FORM APPROVED
OMB NO. 1004-0137
Expires: January 31, 2018**SUNDRY NOTICES AND REPORTS ON WELLS**
Do not use this form for proposals to drill or to re-enter an abandoned well. Use form 3160-3 (APD) for such proposals.5. Lease Serial No.
NMNM95641

7. If Unit or CA/Agreement, Name and/or No.
NMNM1140068. Well Name and No.
TBM FEDERAL COM 019. API Well No.
30-025-37343-00-S110. Field and Pool or Exploratory Area
N LUSK11. County or Parish, State
LEA COUNTY, NM**SUBMIT IN TRIPLICATE - Other Instructions on page 2**1. Type of Well
☒ Oil Well ☐ Gas Well ☐ Other2. Name of Operator
COG OPERATING LLCContact: ABGAIL ANDERSON
E-Mail: abbym@bcmmandassociates.com3a. Address
ONE CONCHO CENTER 600 W ILLINOIS AVENUE
MIDLAND, TX 79701-42873b. Phone No. (include area code)
Ph: 432-580-71614. Location of Well (Footage, Sec., T., R., M., or Survey Description)
Sec 8 T19S R32E NENW 900FNL 1980FWL**12. CHECK THE APPROPRIATE BOX(ES) TO INDICATE NATURE OF NOTICE, REPORT, OR OTHER DATA**

**** BLM REVISED ** BLM REVISED ** BLM REVISED ** BLM REVISED ** BLM REVISED ******FOR RECORD ONLY***X7 NMOC D 10-11-19*

Author:	MRM (7/2017)	
Well Name	TBM Fed	Well No. #1
Field	Lusk Morrow	API #: 30-025-37343
County	Lea	Prop #: 35181
State	New Mexico	Zone: Morrow
Spud Date	8/11/2005	900 FNL & 1980 FWL
GL	3,636'	Sec 08 T19S R32E
KB	3,653'

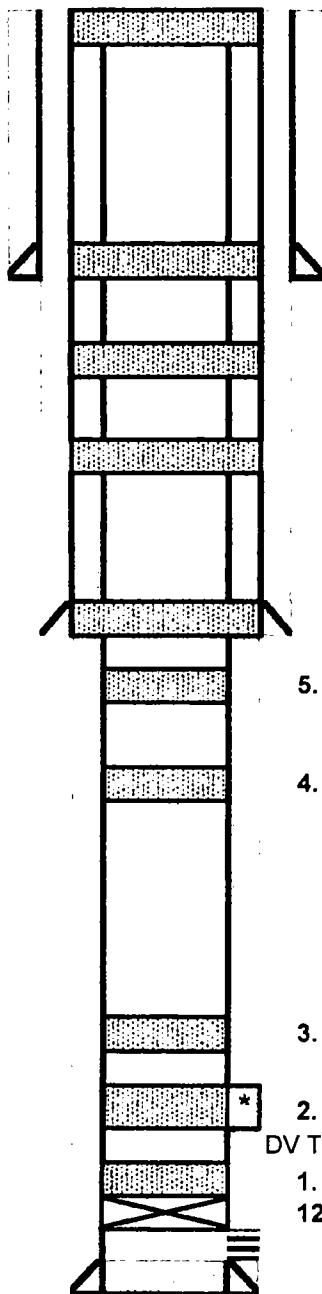
Below ground level dry hole marker required
